I-195 Relocation - Contract 14(West side city streets)

NOTICE TO PROSPECTIVE BIDDERS

ADDENDUM NO. 2 Prospective bidders and all concerned are hereby notified of the following changes in the Plans, Specifications, Proposal and Distribution of Quantities for this contract. These changes shall be incorporated in the Plans, Specifications, Proposal and Distribution of Quantities, and shall become an integral part of the Contract Documents.

DESIGNED BY: JOK/CC
CHECKED: KRC
DATE: OCTOBER 2012
SHEET: V1_044
OF: V1_260

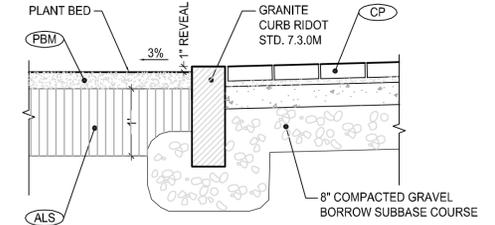
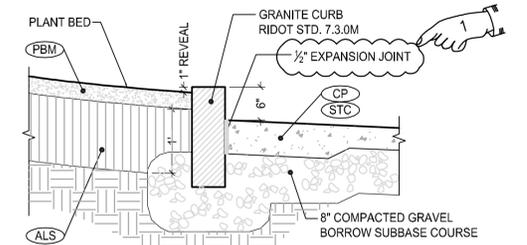
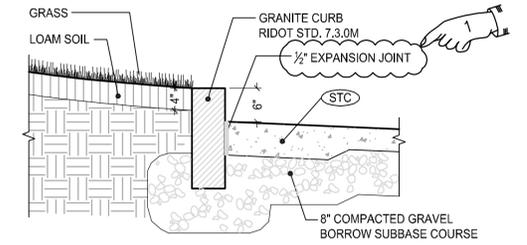
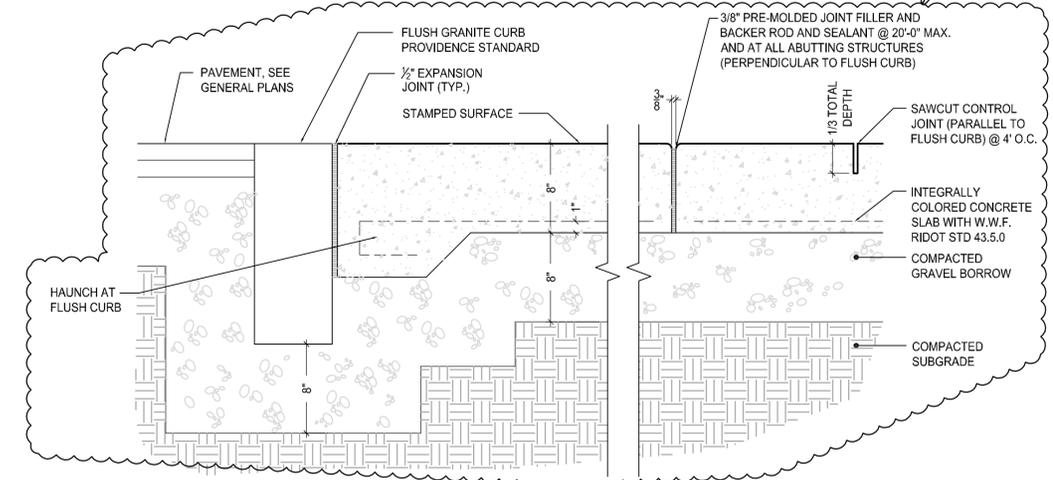
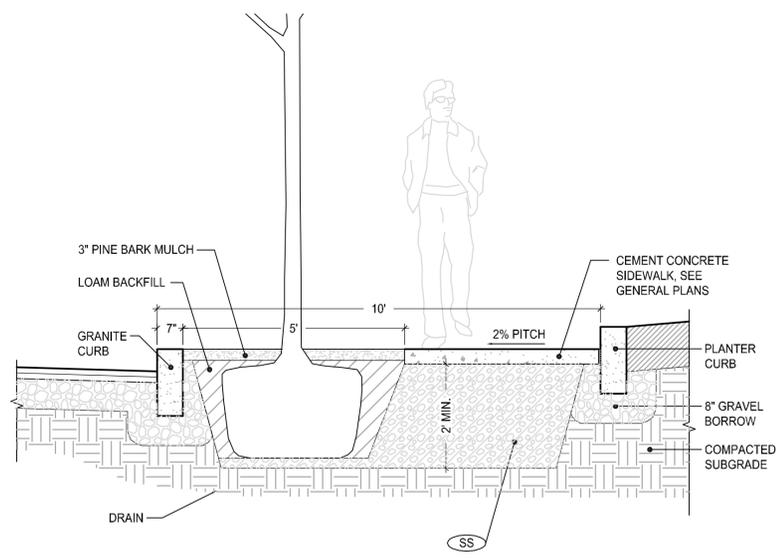
1. Sheet V1_044
Delete Sheet V1_044 in its entirety and replace it with Sheet V1_044(R-1) attached to this Addendum No. 2. The details have been revised.
2. Sheet V1_046
Delete Sheet V1_046 in its entirety and replace it with Sheet V1_046(R-1) attached to this Addendum No. 2. The details have been revised.

DESIGNED BY:
 CHECKED:
 DATE:
 SHEET: V1_049
 OF: V1_260

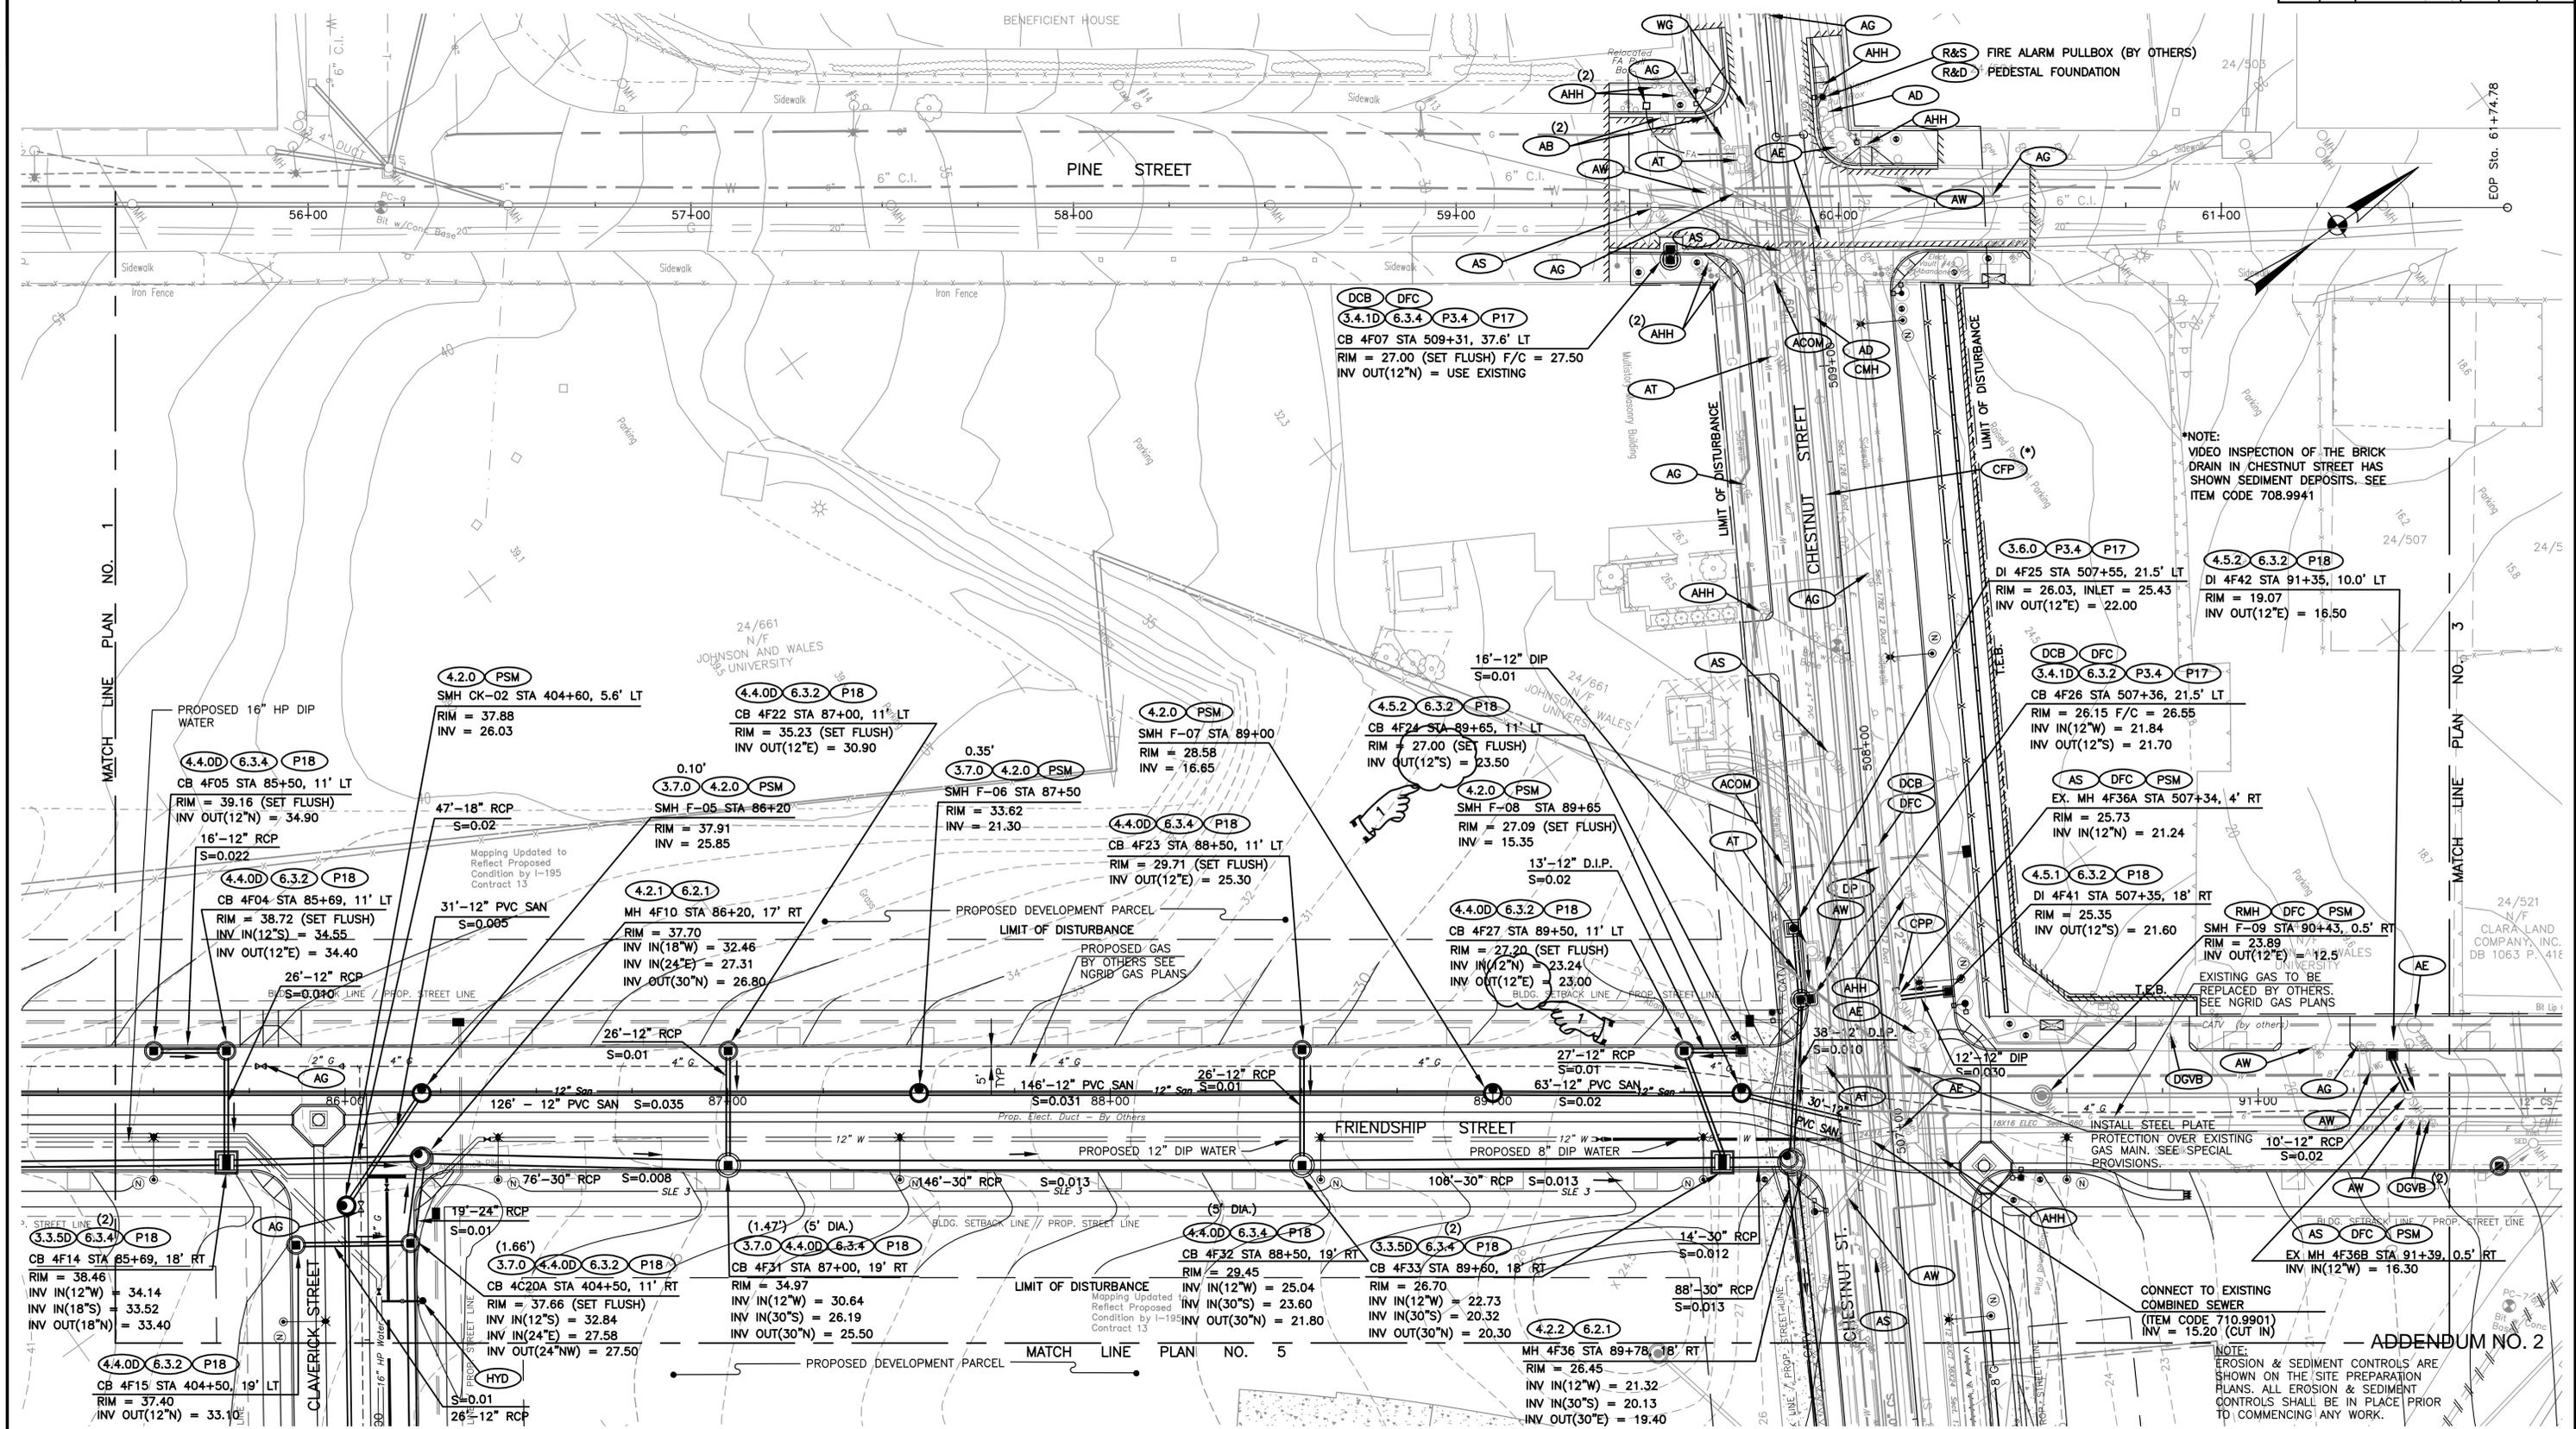
3. Sheet V1_049

Delete Sheet V1_049 in its entirety and replace it with Sheet V1_049(R-1) attached to this Addendum No. 2. Callouts have been revised.

DESIGNED BY:
 CHECKED:
 DATE:
 SHEET: V1_060
 OF: V1_260

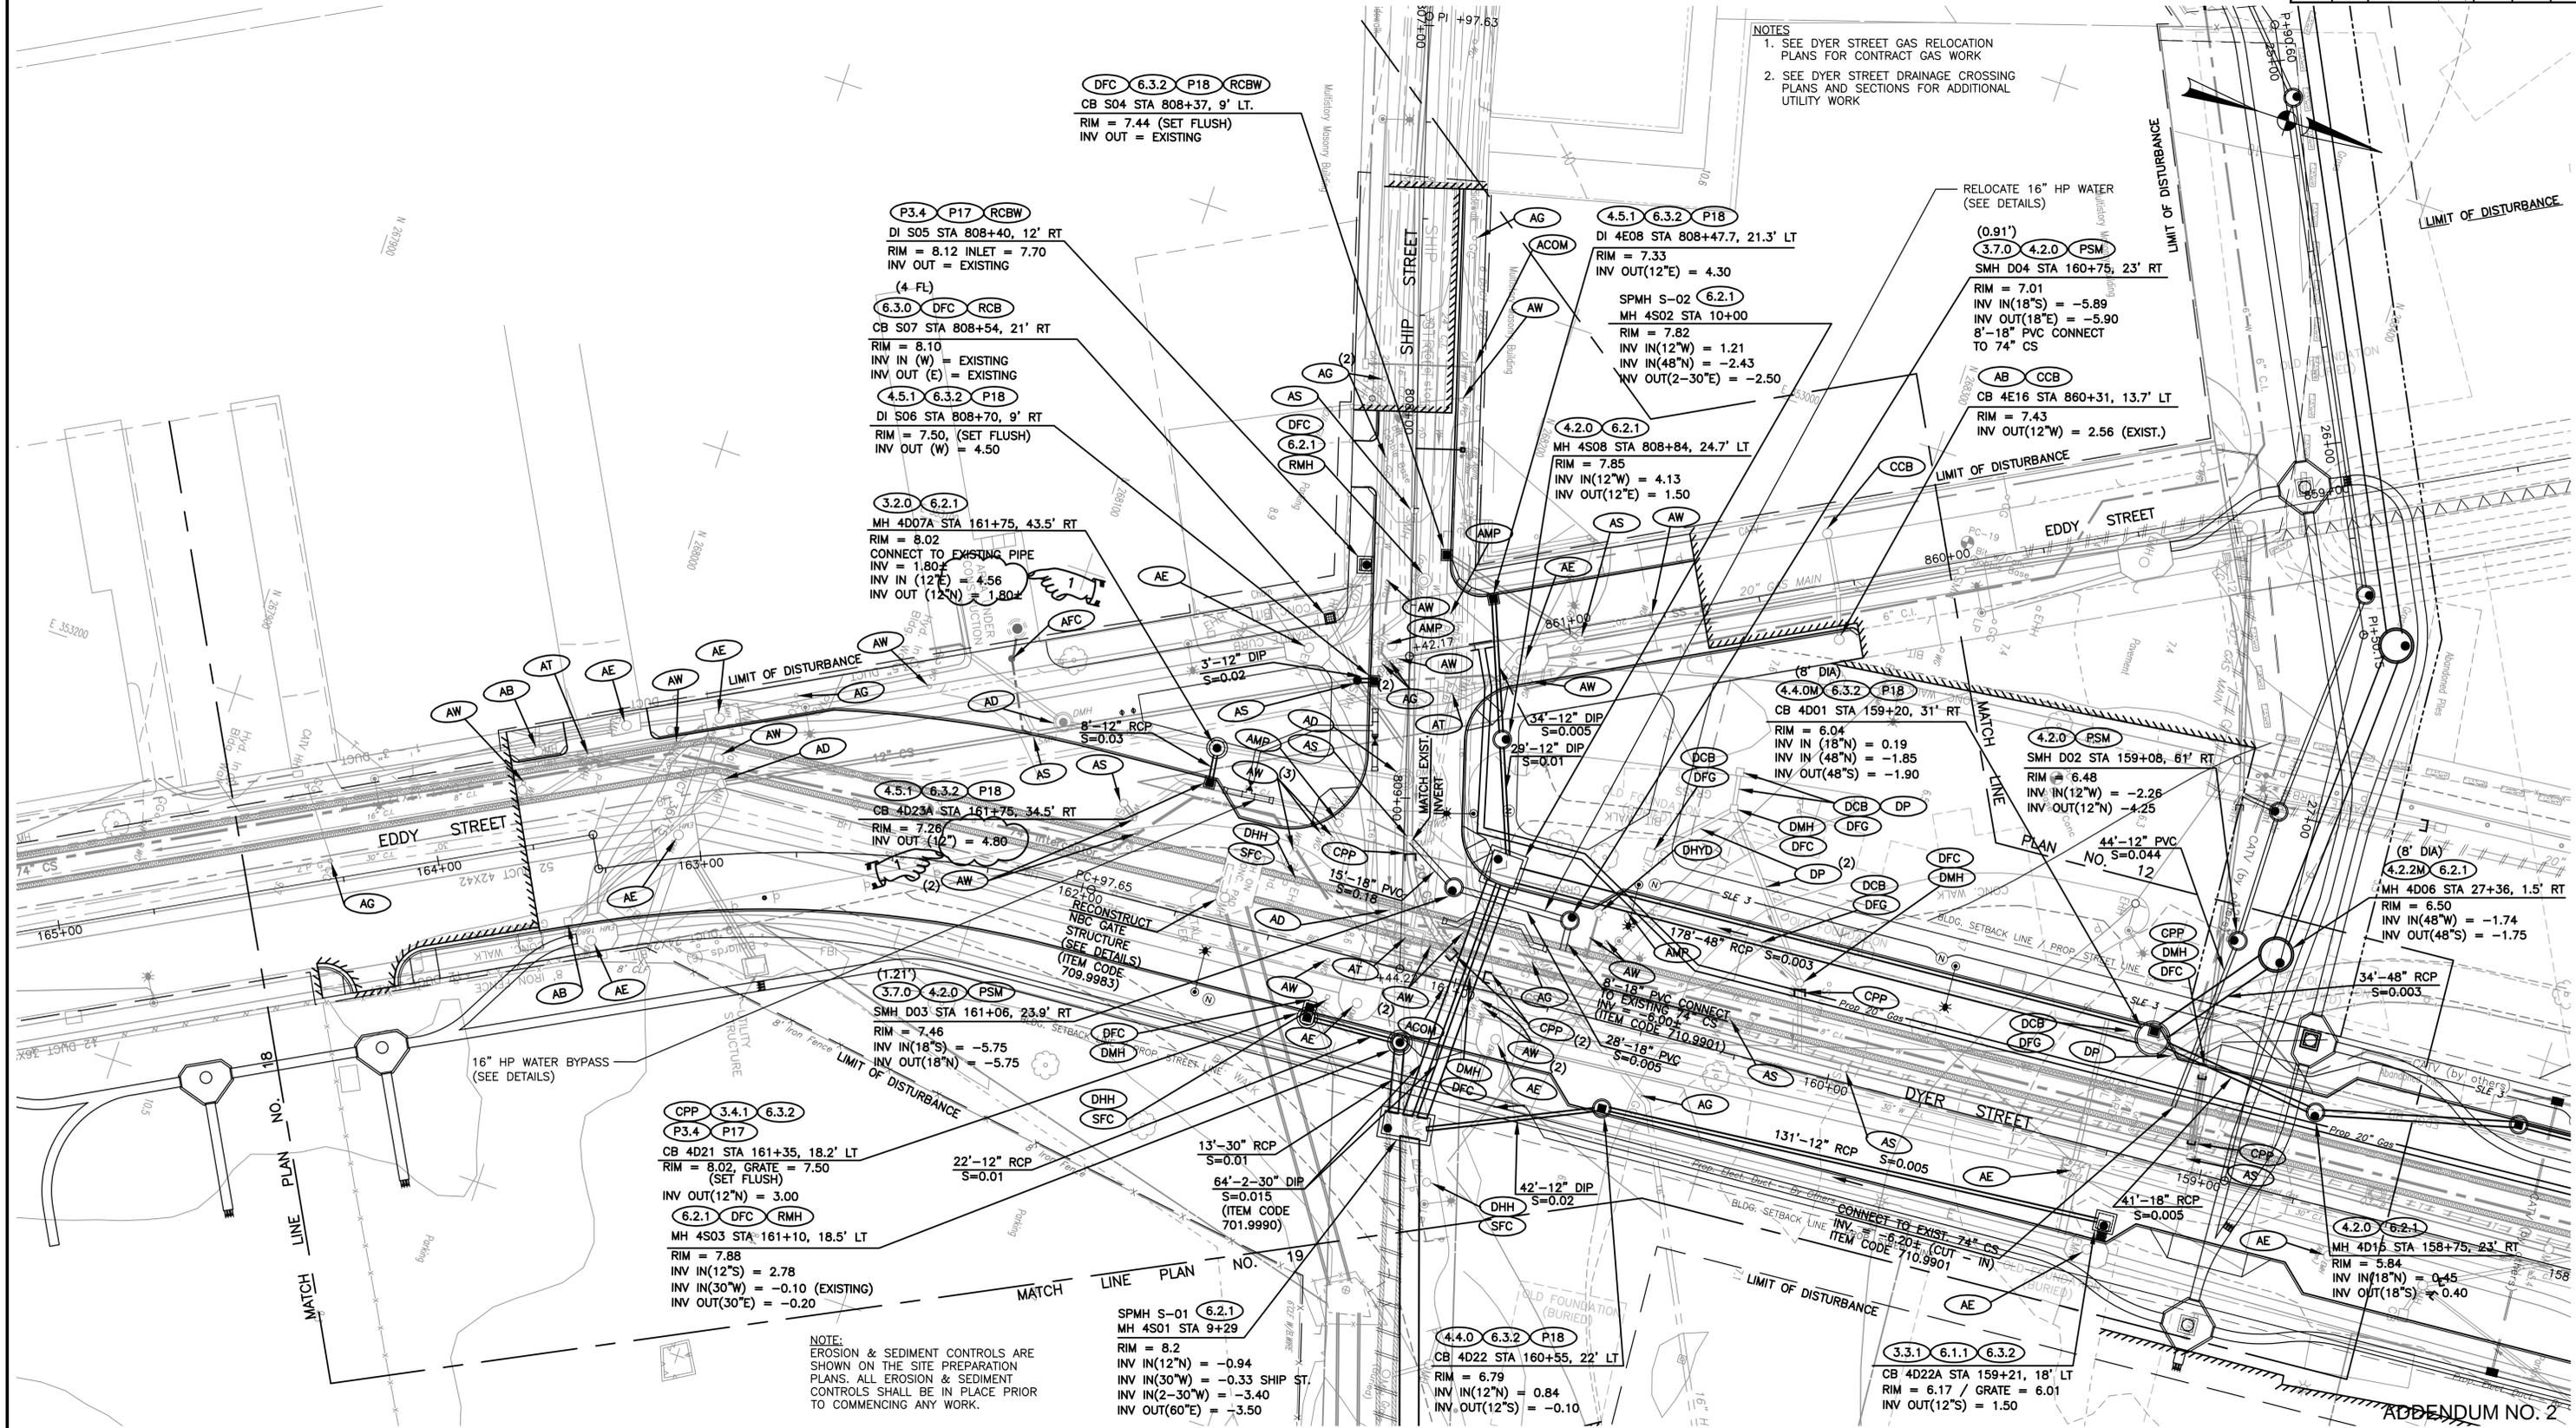
4. Sheet V1_055

Delete Sheet V1_055 in its entirety and replace it with Sheet V1_055(R-1) attached to this Addendum No. 2. Callouts have been revised.
